THE MAIDS MORETON & FOSCOTE ACTION GROUP

Objections to Discharge of Conditions

Planning Application PL/25/5939/CONDA

OBJECTION TO DISCHARGE: Condition 7 – Adoptable Roads

Plan 2 – overlay of site plan and rights of way layer

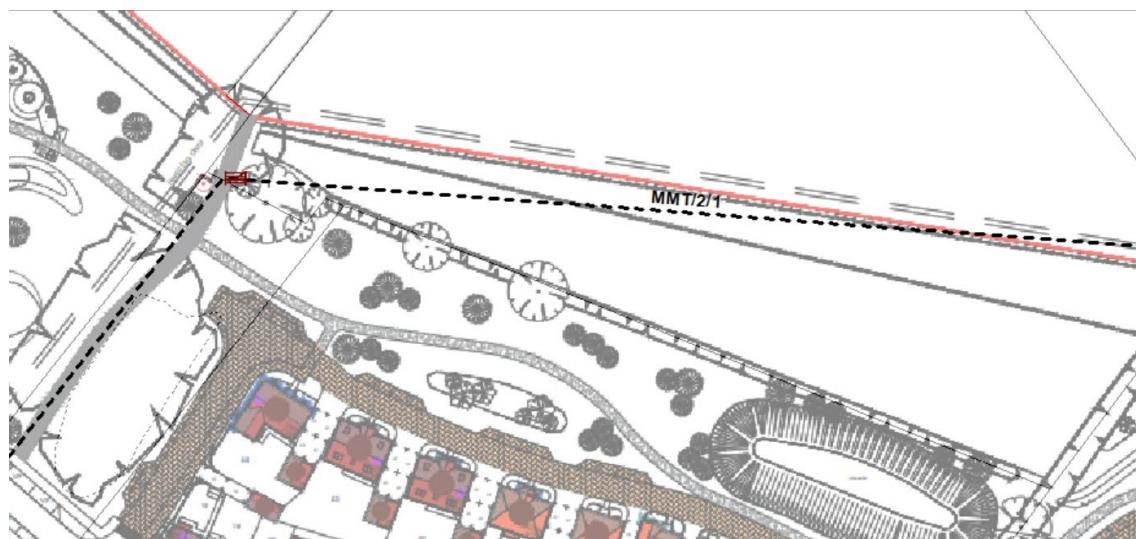
The current alignment of Maids Moreton Footpath No. 2 (MMT/2/1) is sufficiently altered by the development in the amended plans to require a diversion. This can be achieved using s257 TCPA 1990 when “*...it is necessary to do so in order to enable development to be carried out.*” I believe this is *necessary* as there is a new hedge and possibly a fence erected [just south of the red edge] across the footpath on the northern boundary.

However, I’m concerned the footpath appears to shift outside the red edge and possibly onto 3rd party land – see Plan 2. This also requires moving the existing gate, situated between the development and agricultural land, to the north. Further information and/or a revised plan is required to address this matter.
